Shift Cable Measurements For Transmissions

Models

Hurth 630A, Hurth 630V: All Ratio's
Velvet Drive 5000A, 5000V: All Ratio's
Note: This does not include 71C and 72C Transmissions

73284

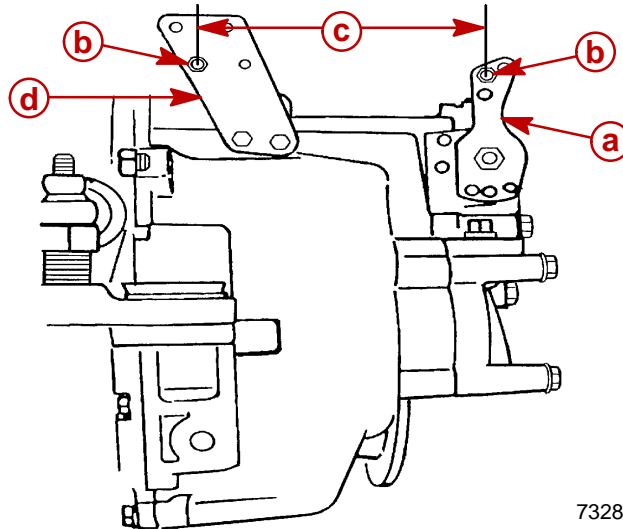
The distance between the anchor stud and shift lever stud, Dimension C shown in the following illustration, is set at 7-1/8 in. (181 mm). This dimension should supersede any previous dimensions supplied in Service Manuals or Installation Manuals for MerCruiser inboards.

- a** - Shift Lever
- b** - Anchor Stud
- c** - Dimension Between Studs - 7-1/8 in. (181 mm)
- d** - Shift Cable Bracket
